23/65-05C **REVISION** 203 Market St  
Brookeville Historic District

*scops*  
**CHIMNEY OPTIONS**  
CHIMNEY OPTIONS - 14 SEPT 05

Project:  
**SCANLON HOUSE**  
203 Market Street  
Brookville, Maryland 20833  
Montgomery County

Revision of approved design for construction of a new single-family home. Generally the changes include deepening the front porch, tapering the chimney; battering the porch columns and straightening the piers; changing the porch piers materials to shingle with brick bases; and modifying the location, size and types of numerous windows. An explanation for the changes is provided on Circle 7. The specific changes – those that were not approved at the Staff level – are listed below:

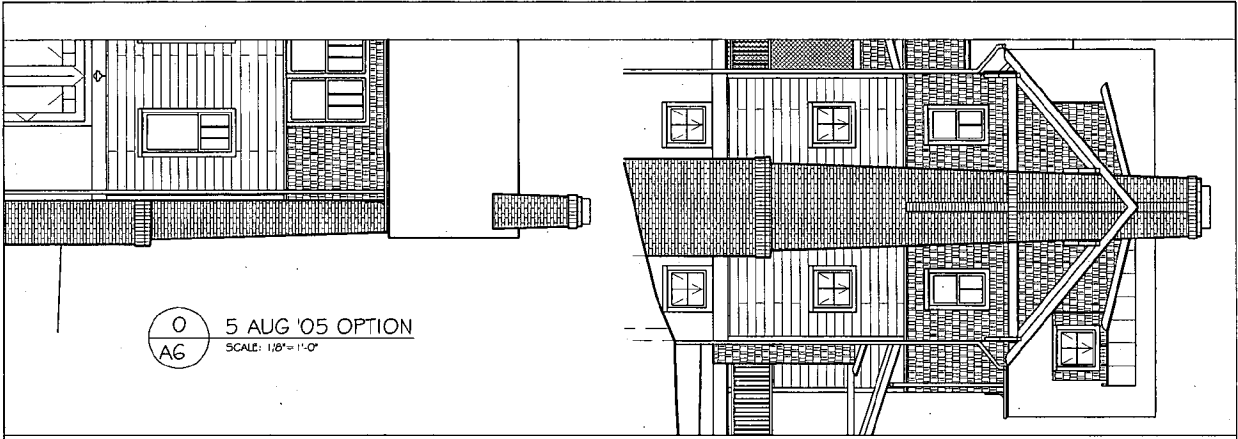
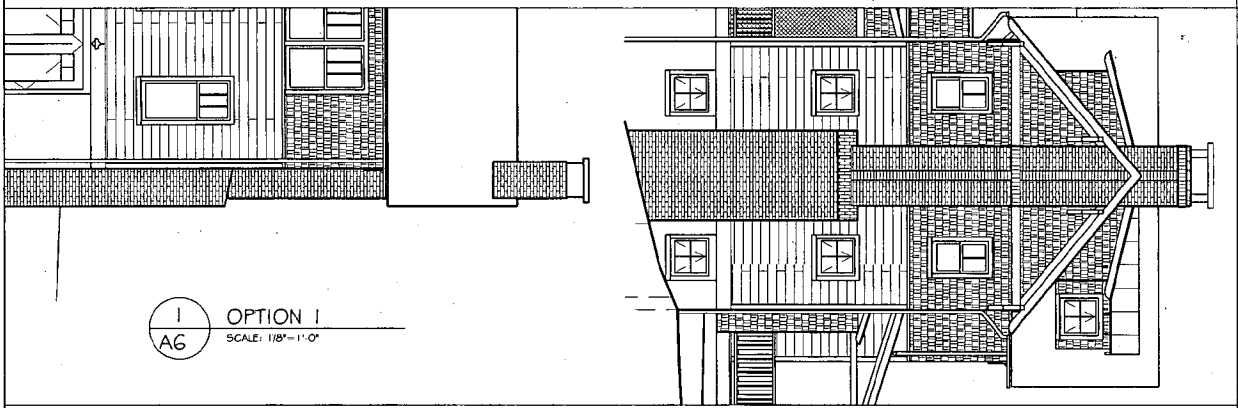
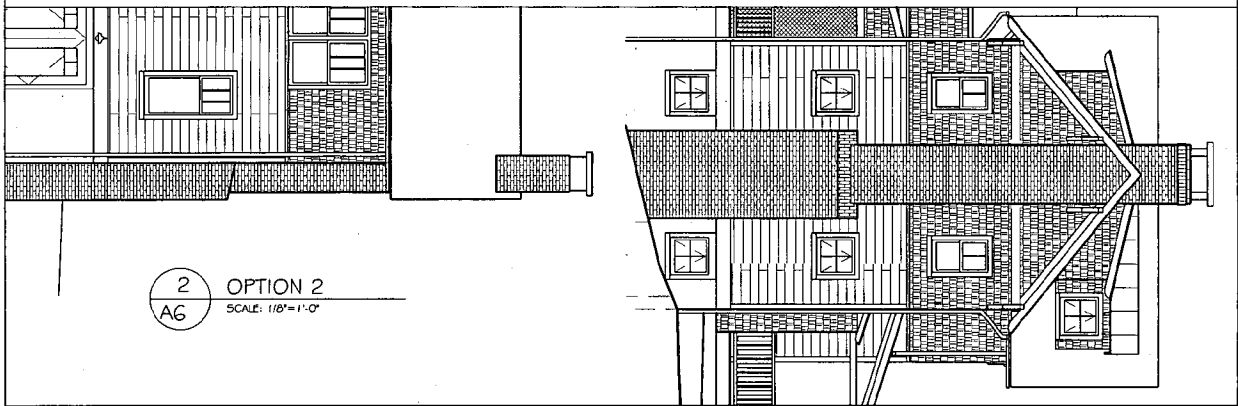
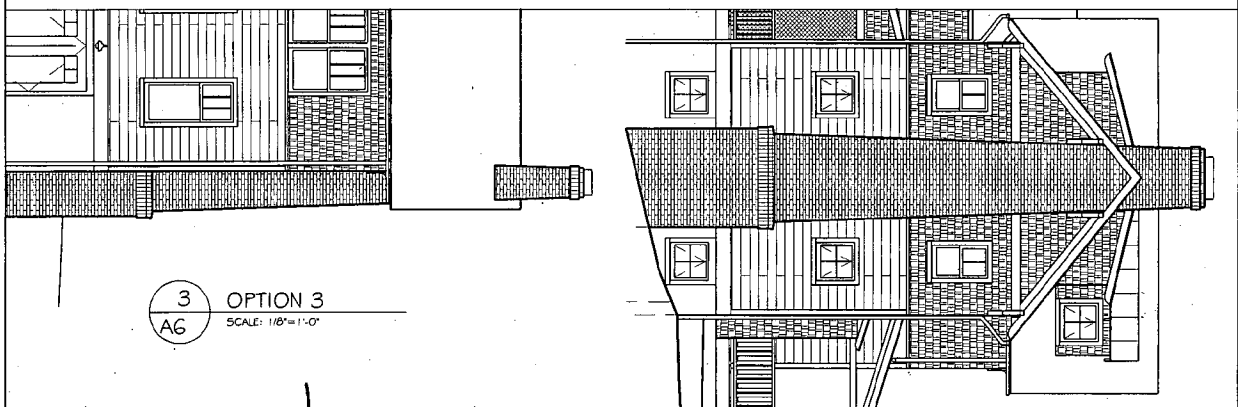
3 The other relatively large change is the chimney. And they were given the  
4 leeway to make some material changes, so you know, switching it to brick has already  
5 been approved, but it's, they changed the shape. It was just a straight chimney, and now  
6 it's a battered chimney.

The chimney shape change was for aesthetic reasons. We wanted to continue the "battered" theme from the porch columns and didn't like the "tacked on" look that the chimney had before when it was smaller. It looked undersized and out of proportion being so tall and narrow.

The design presented in the revised HAWP contains refinements to features while retaining the approved vernacular Craftsmanesque style and massing. Discussions by the Commission regarding the details of the design (See Circles 33-69 for minutes) centered on simplification, unification and differentiation. Most of the revisions meet these goals. The window changes continue to help unify and simplify the appearance of the house, which fluctuates due to the grade and they clean up the end elevation most visible from the Madison House and the future Race Street. The chimney redesign, however, does not fit – it changed from a straightforward chimney to one that is battered and more appropriate to a high style house. Staff recommends approval of the revised HAWP with the condition that the chimney is redesigned so as to be simpler and not battered.

Approved driveway w/ new house loc

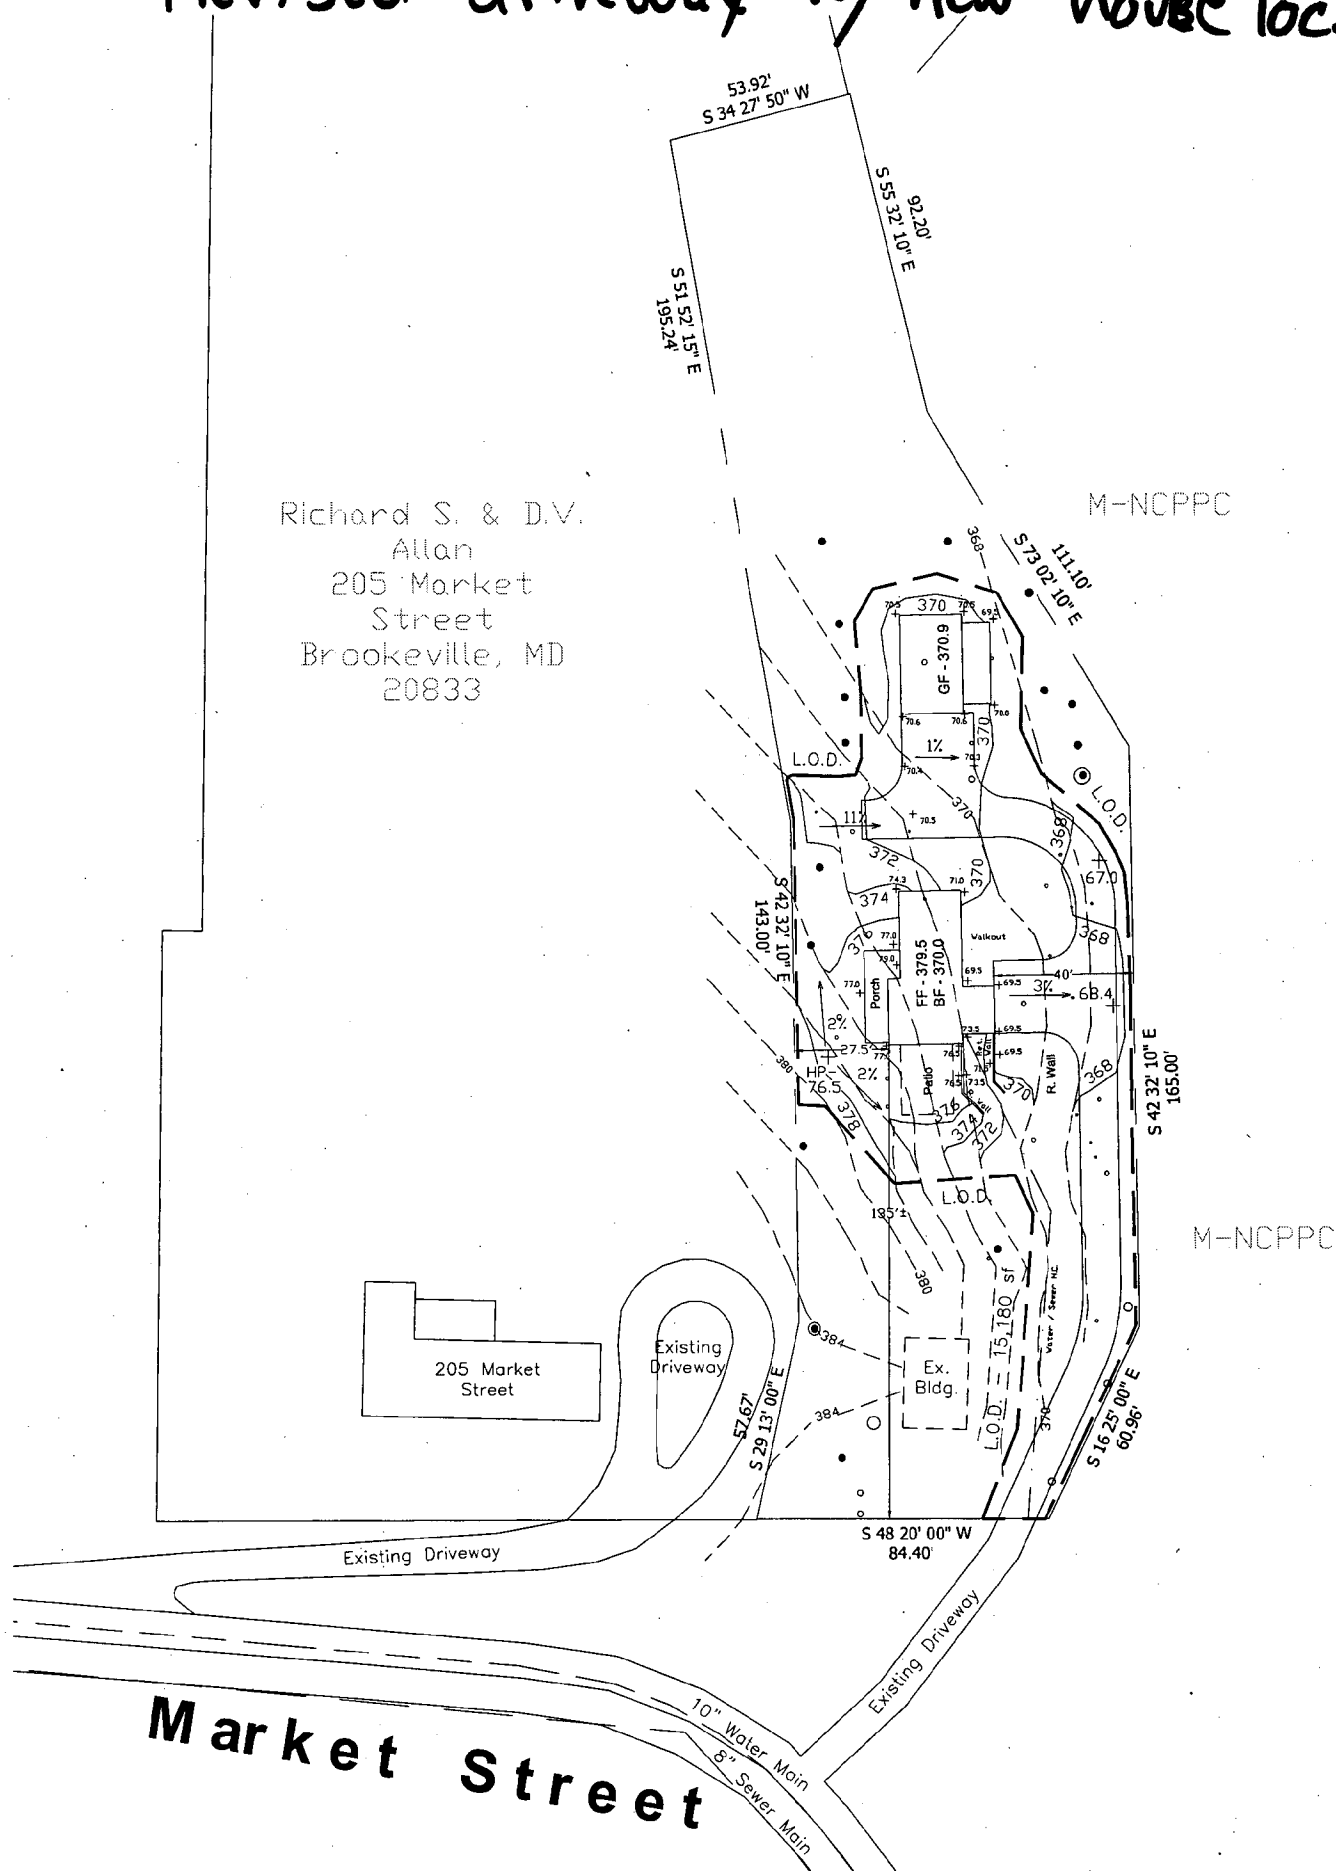
Revised driveway w/ new house loc.

- The driveway selection is the preferred option of the Commission. - OK
- Tree protection plan has been prepared - OK
- Due to grading issues the new house is now sited farther away from the historic stone house (83' vs. 50'). This eliminated space for the shed, reduces the length of the rear driveway, and places the house closer to the proposed barn. - OK
- Footprint is smaller – now 907.125 - OK
- Front porch is 6' deeper - OK

STAFF SUGGESTION

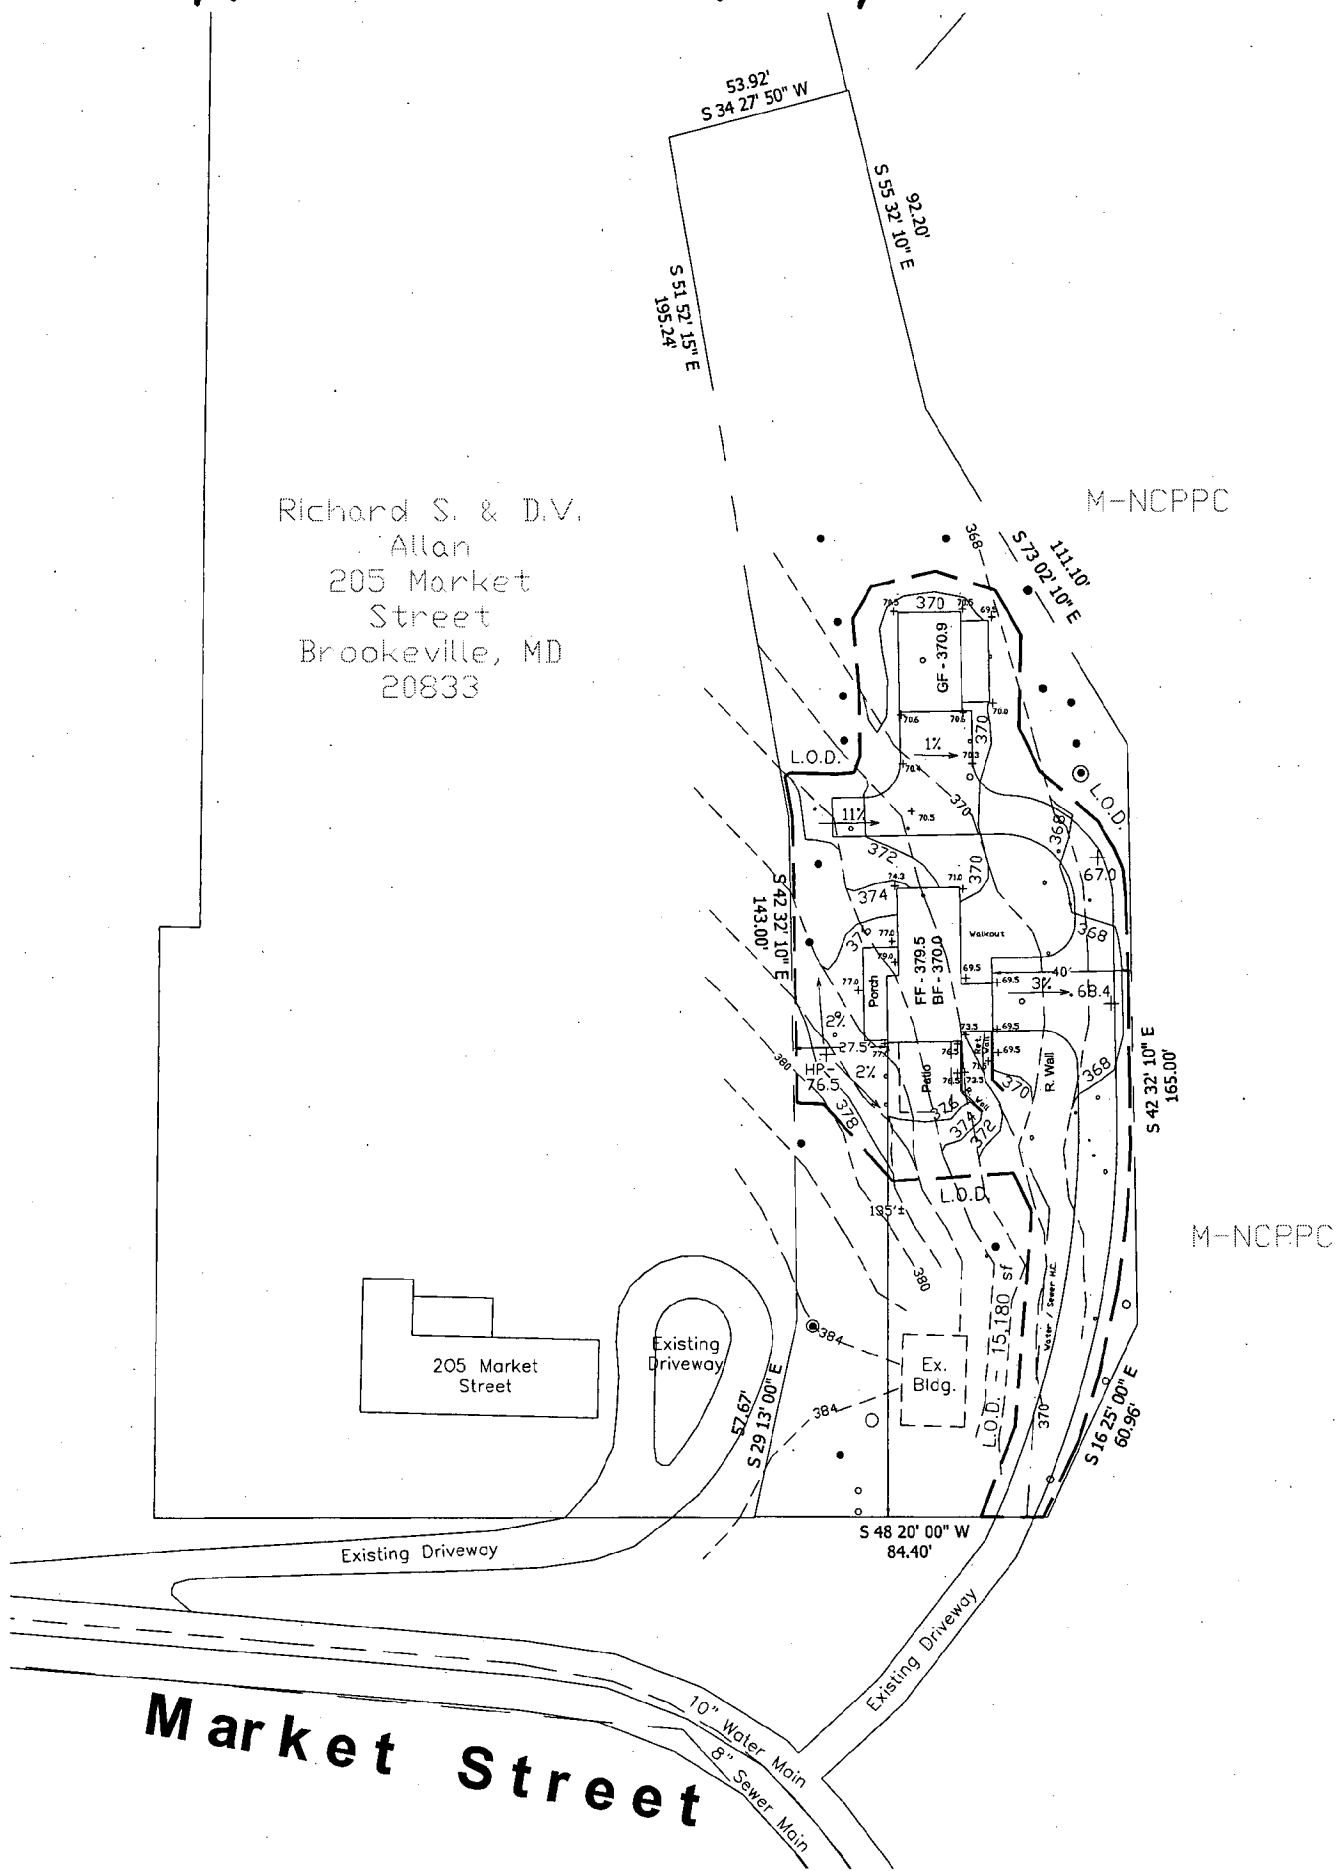
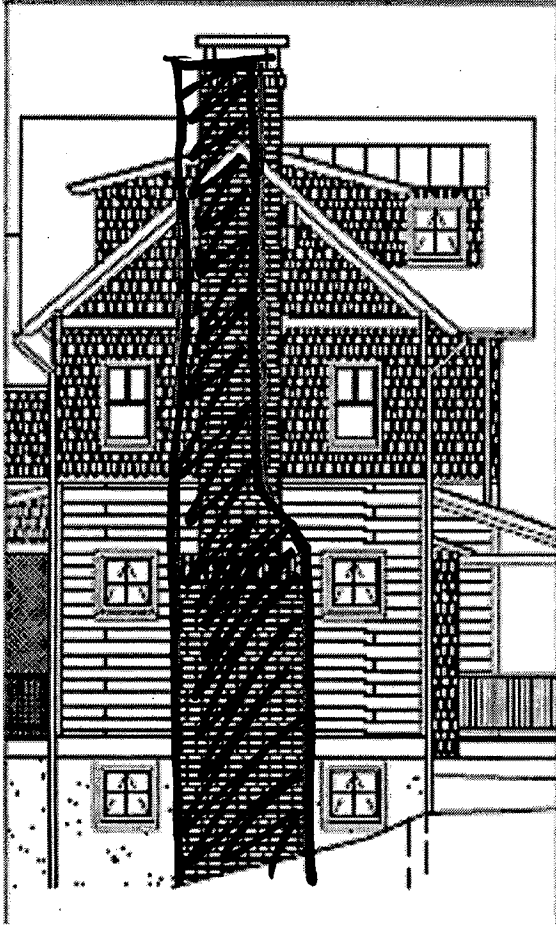
Here's a slightly revised version that pulls the drive closer to the property line and shortens the turnaround over by the detached barn/shop. This will provide for a little more green space.
